UNITED STATES PATENT AND TRADEMARK OFFICE

| APPLICATION NO. | FILING DATE | FIRST NAMED INVENTOR | ATTORNEY DOCKET NO. | CONFIRMATION NO. |
|-----------------|-------------|----------------------|---------------------|------------------|
| 09/822,154 | 03/30/2001 | Robert A. Immerman | IN0191US (#90067) | 6306 |

Office Action Summary

This is the fifth office action for serial number 09/822,154, Suction Cup Holder, in response to RCE filed July 17, 2003.

3,181,702

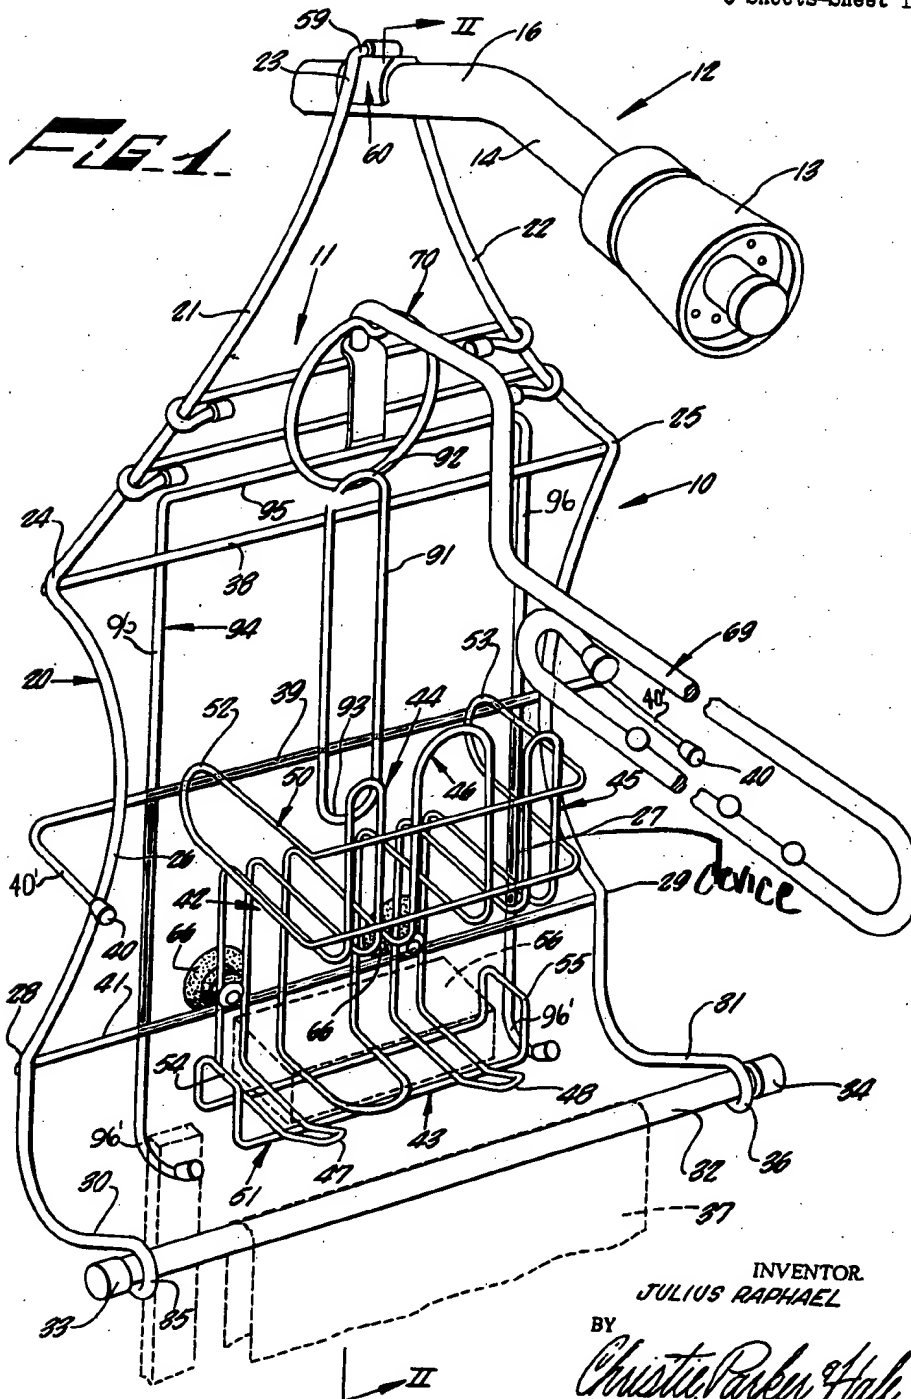
Claims 1, 2, 4, 11, 12, and 14 are rejected under 35 U.S.C. 102(b) as being anticipated by Raphael 3,181,702. Raphael discloses a first pair of horizontal wires (39 and 41), a second pair transverse wires (96), the wires defining a generally vertical rectangular opening (see attached figure), a suction cup with a head and a neck), two fastener arrangements (where the wires are attached to the fixture), and a fixture

(50, 42, 43, 51, 52, 47, 48 and 53). The horizontal wire (41) retains the neck of the suction cup (66) within the opening. The wires are attached to the fixture by welds or at least one brazing(column 2, lines 56ff, where 52 and 53 are attached to 39 and where 47 and 48 are attached to 41).

Claims 3, 5, 13, and 15 are rejected under 35 U.S.C. 103(a) as being unpatentable over Raphael 3,181,702. Raphael discloses all of the limitations of the claimed invention except for the fastener arrangement being fastened to the fixture by soldering or adhesive. The further limitation of the device being fastened to the fixture by soldering or by adhesive is a design choice and the applicant did not disclose any reason for why the device and the fixture critically had to be fastened with one of those techniques. Therefore, it would have been
